SUBJECT: CYCLE 6 RELOAD, SUSQUEHANNA STEAM ELECTRIC STATION, UNIT 1 (TAC NO. 77165)

ATTACHMENT TO LICENSE AMENDMENT NO. 102

SAFETY EVALUATION BY THE OFFICE OF NUCLEAR REACTOR REGULATION
SUPPORTING AMENDMENT NO. 102 TO FACILITY OPERATING LICENSE NO. NPF-14

SUSQUEHANNA STEAM ELECTRIC STATION UNIT NO. 1

MAXIMUM AVERAGE PLANAR LINEAR HEAT GENERATION RATE (MAPLHGR) VERSUS AVERAGE BUNDLE EXPOSURE ANF 8X8 FUEL FIGURE 3.2.1-1

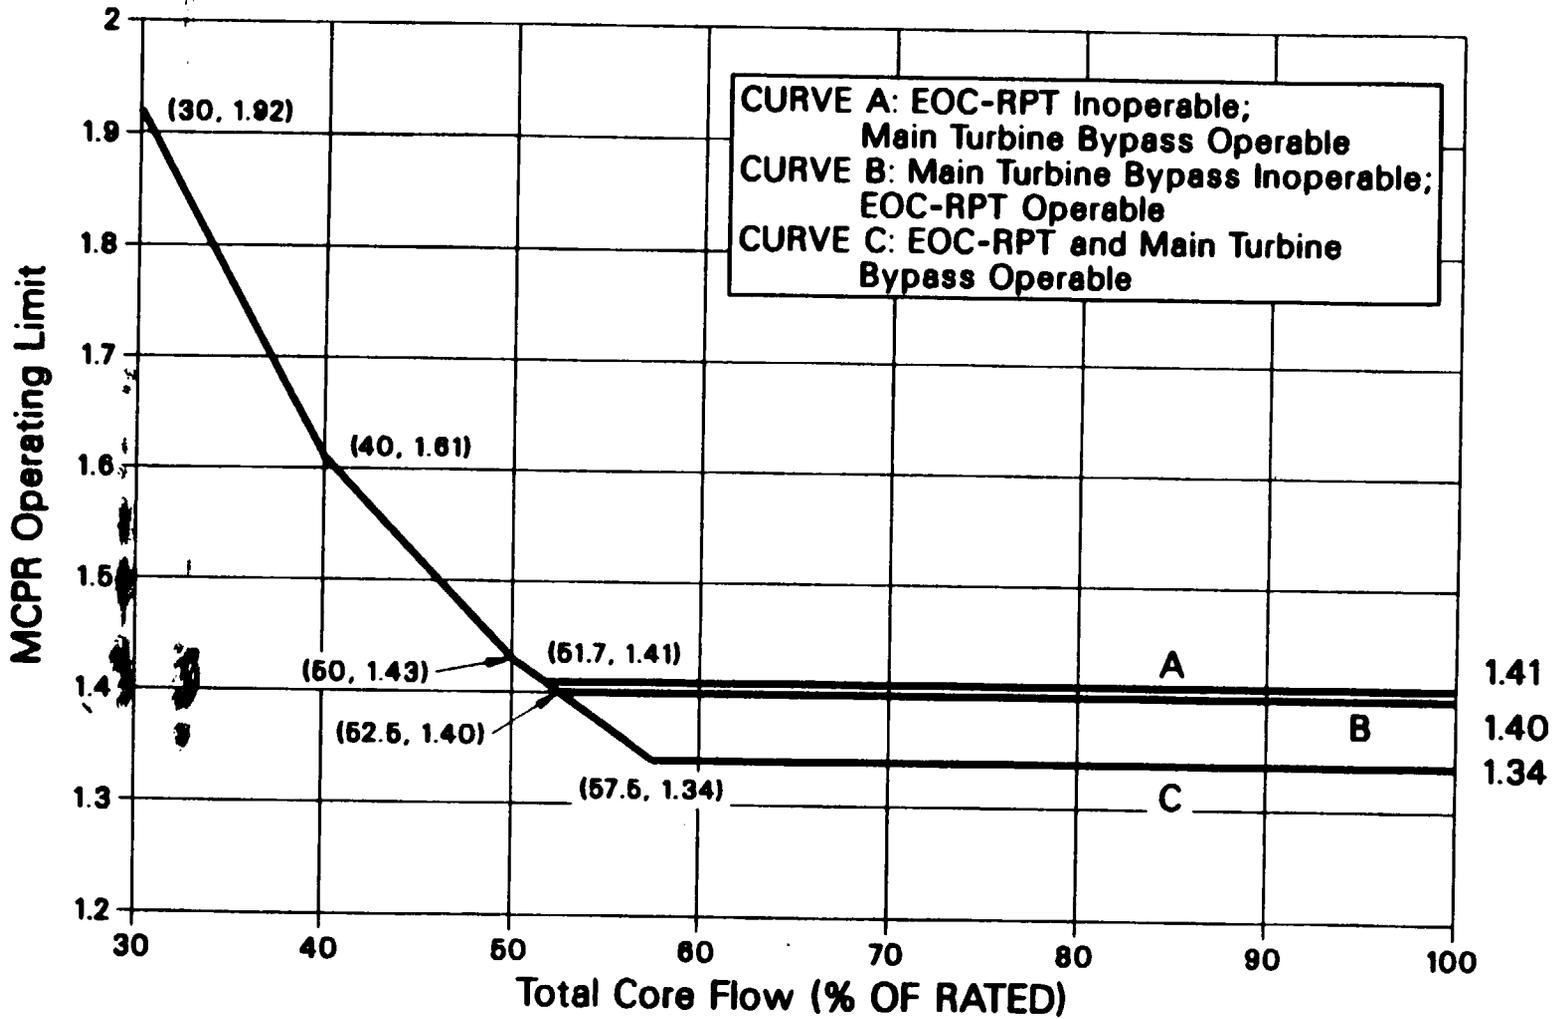
- (1) TS 3/4.2.1 -- Figure 3.2.1-1 is changed to reflect the approved burnup extension of ANF 8x8 fuel to 37,000 MWD/MTU for average bundle exposure, which was previously discussed. This is acceptable.

**FLOW DEPENDENT MCPR OPERATING LIMIT
FIGURE 3.2.3-1**

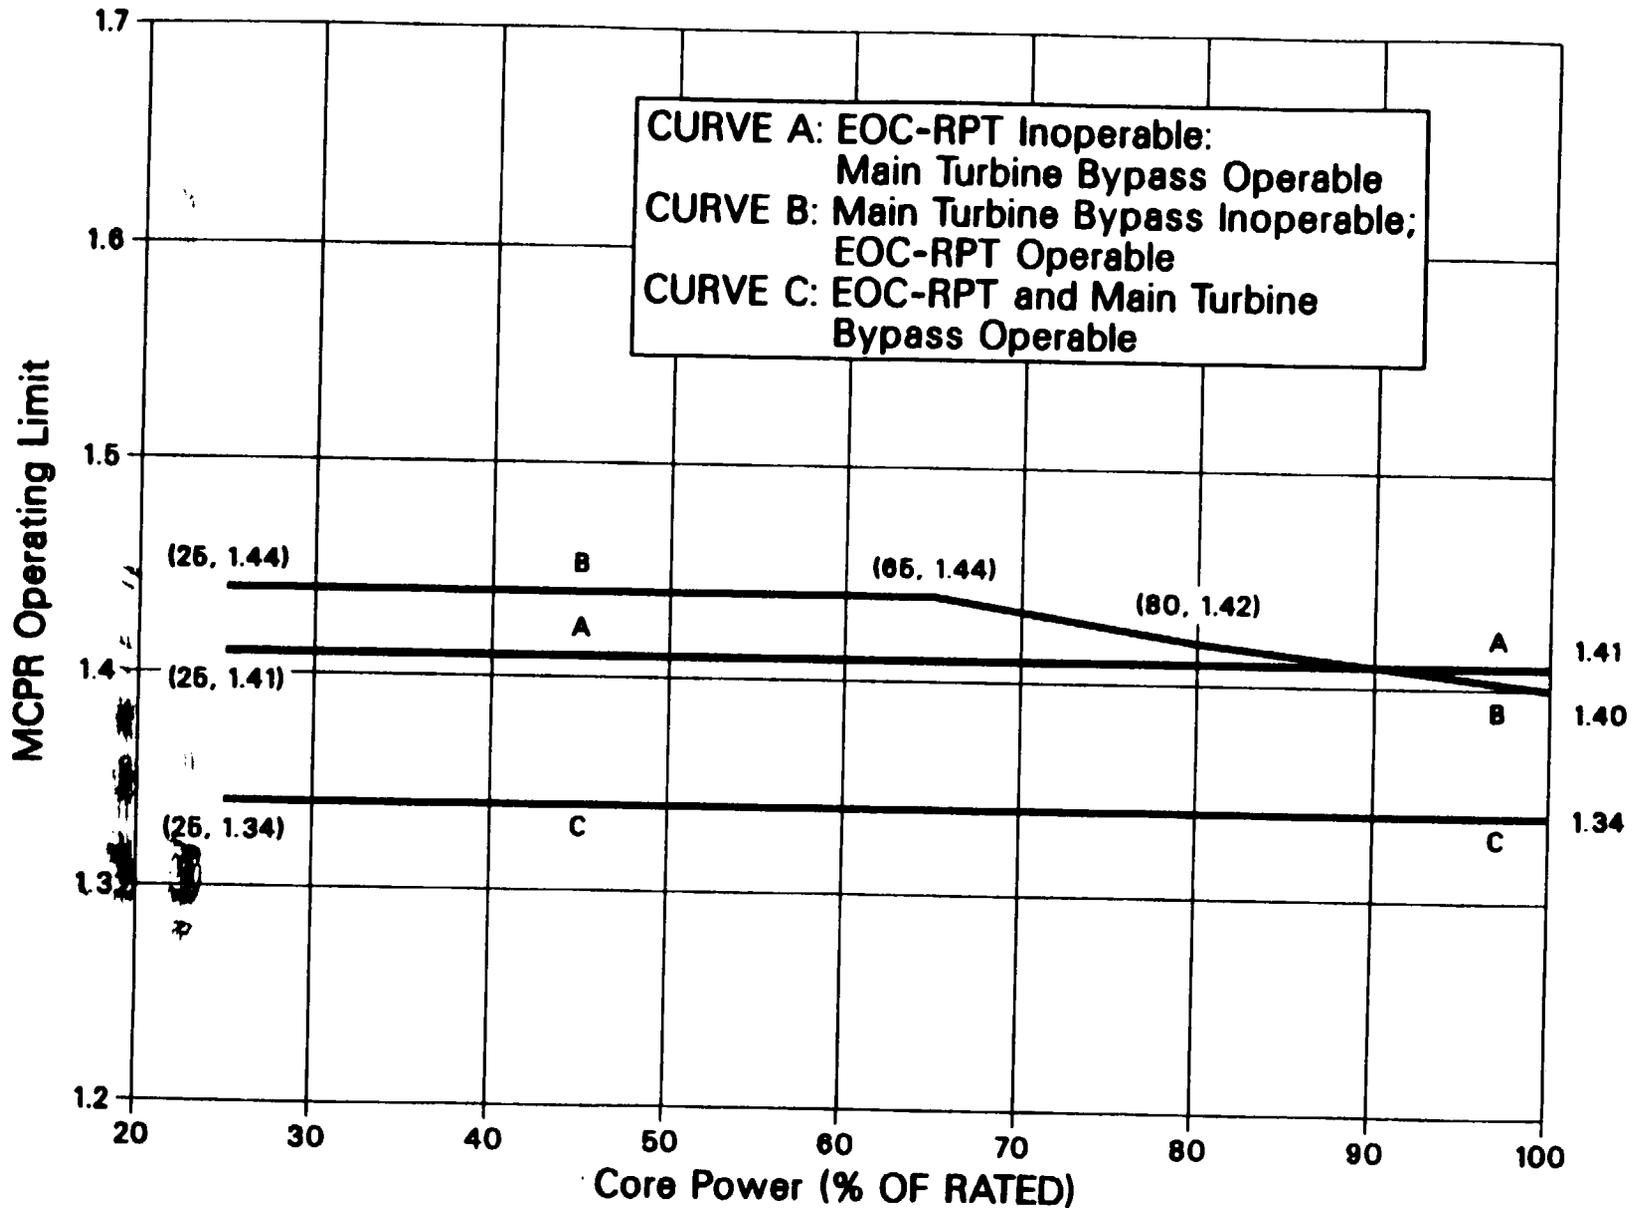
- (2) TS 3/4.2.3 -- Figures 3.2.3-1 and -2 are changed to reflect the new calculations of flow and power dependent MCPR operating limits using the parameters of S1C6. As previously discussed, these analyses have been approved and the changes are acceptable.
